**Application by National Grid Electricity Transmission (NGET) for a  
Development Consent Order (DCO) for the proposed Norwich to Tilbury  
Project (Application Reference: EN020027)**

**Chelmsford City Council Host Authority reference** [REDACTED]

**Local Impact Report**

**26<sup>th</sup> February 2026**

### Little Waltham

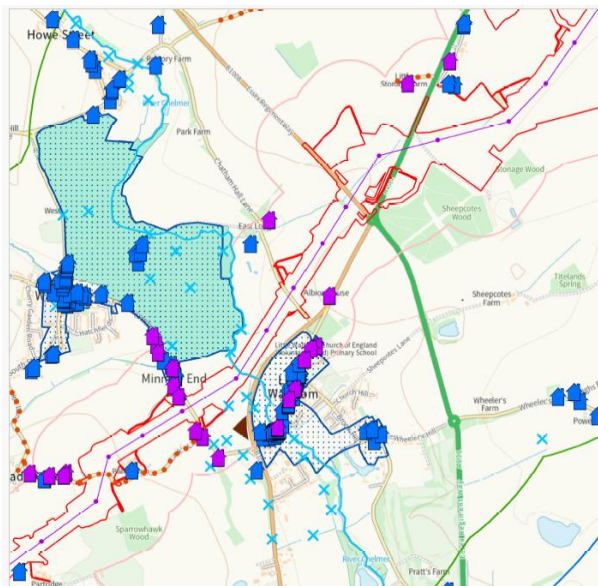
8.48 Langleys has an isolated rural setting, which makes an important contribution to its significance. The introduction of pylons within the setting of the house and garden would irreversibly destroy the unique and irreplaceable historic environment, leading to significant adverse heritage impacts which are not adequately mitigated.

8.49 The Project would also irreversibly destroy the unique and irreplaceable historic environment within Great Waltham and Little Waltham. Whilst some of the harm identified is at the low level, cumulatively there would be an extensive impact

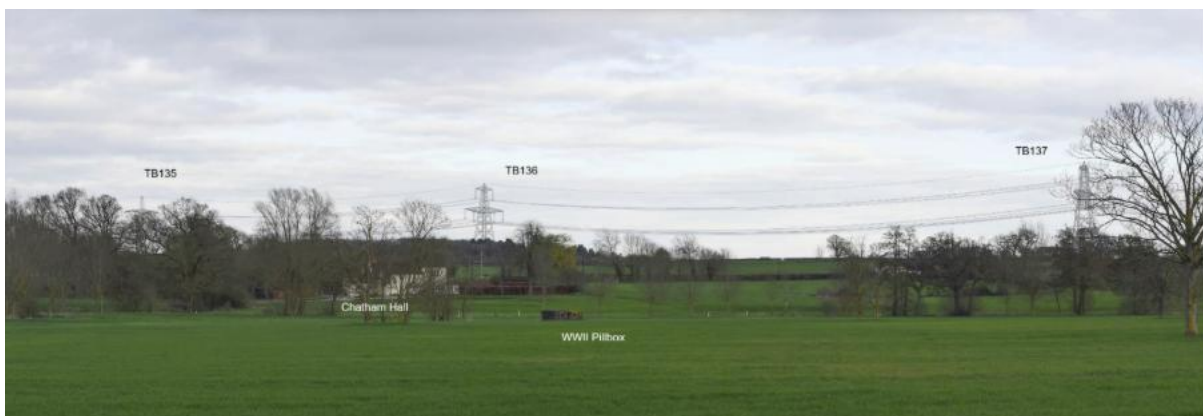
8.199 There are areas with permanent significant impacts are identified at Balls Farm, Great Waltham (1305428), Langleys Registered Park and Garden (1000241), Southwoods Farm, Writtle (1237420 and 1237421), Margaretting Hall (1152104), the Church of St Mary, Stock (listed grade II\*, 1264434) and White's Tyrrells Farmhouse, Stock (1236733). No additional mitigation is proposed, but it is essential.
